Project	COUNTY FLATS, SANDFIELDS
Project number	N297
Client	HALE CONSTRUCTION LTD
Title	BLOCK 03/04 ELEVATIONS 2/2
Drawing number	A014
Scale	1 : 100 at A1
Revision	H
Status	INFORMATION
Drawn	PC
Date	30.11.21

DESIGN CHANGES

01 E06 - Block 3 Open Public Space Elevation
1 : 100

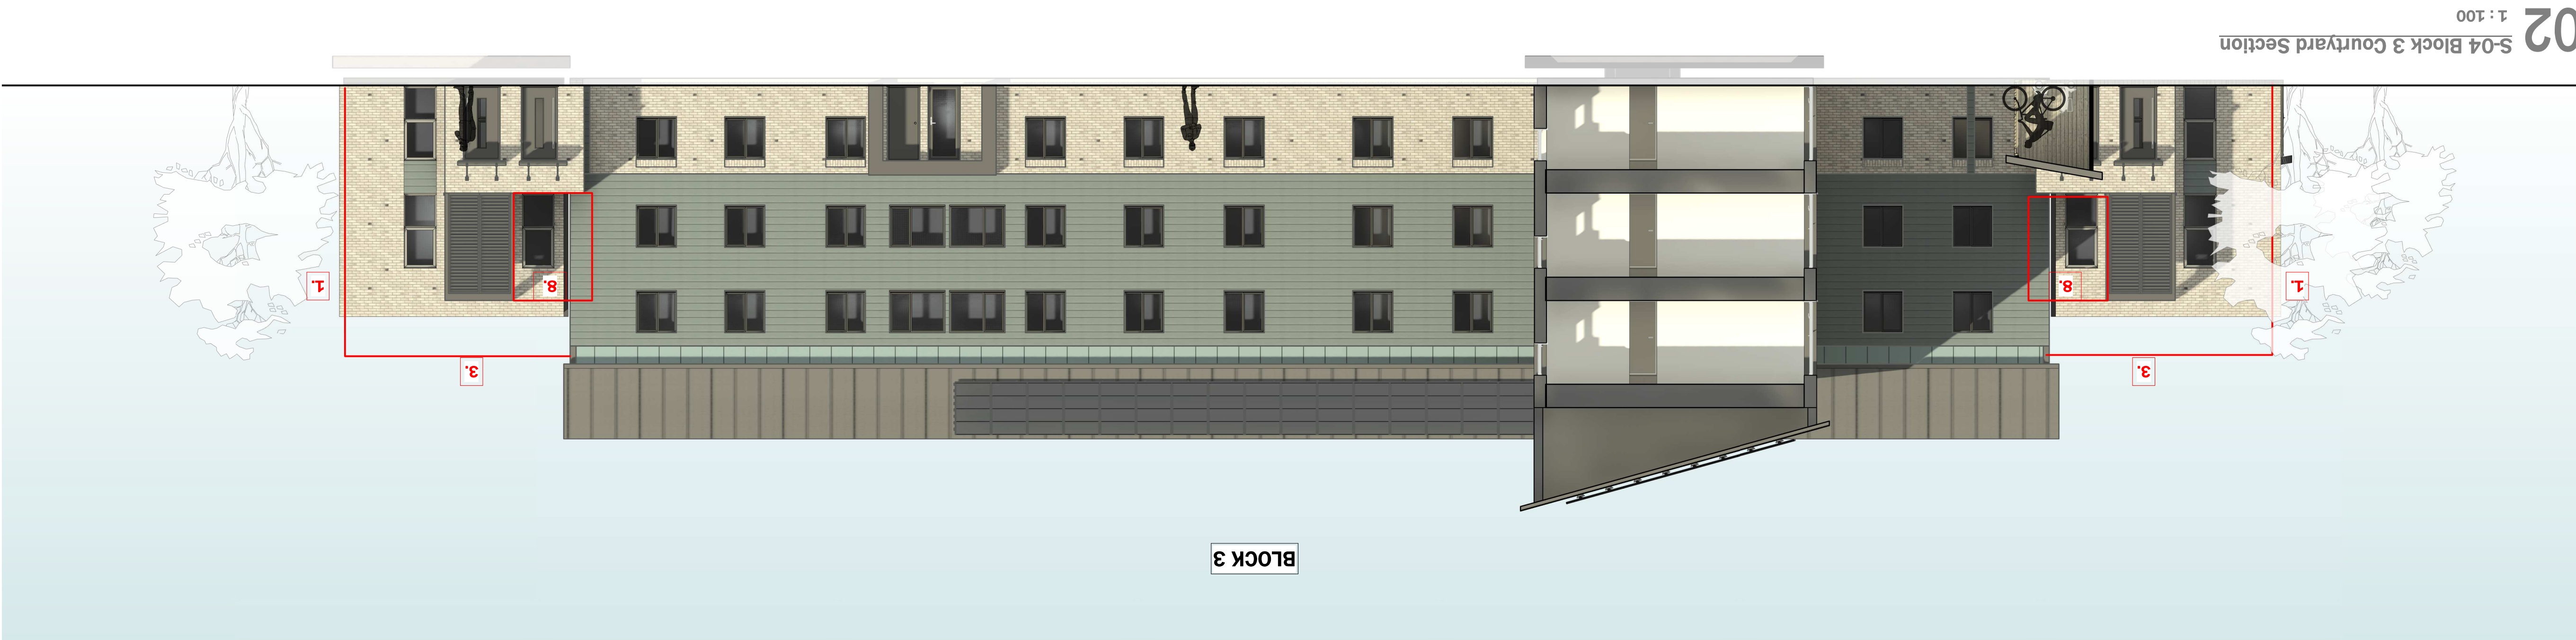
1. Modular and links re-positioned slightly off existing buildings, with the party wall straightened and porch projections aligned with this wall, to ensure modular construction can be achieved off site

2. Windows have been slightly re-positioned to the new build to suit the structural design of the modular units and the constraints of the timber frame.

3. Rapet to modular and blocks have been lowered by approx 500mm to comply with the structural wind loadings and timber frame design.

4. Corner windows have been removed and replaced with 2no. Windows on either corner, again due to the structural and timber frame design of the blocks.

5. PV panels have been omitted from the end modular units to suit the structural and timber frame design of the blocks.

7. Air source heat pump external cover enclosure amended to be single storey over entrance canopy to end link blocks

12. Windows in communal area to the linked blocks made narrower to ensure 1.8m fire separation distance to existing windows is achieved to comply with building regulations.
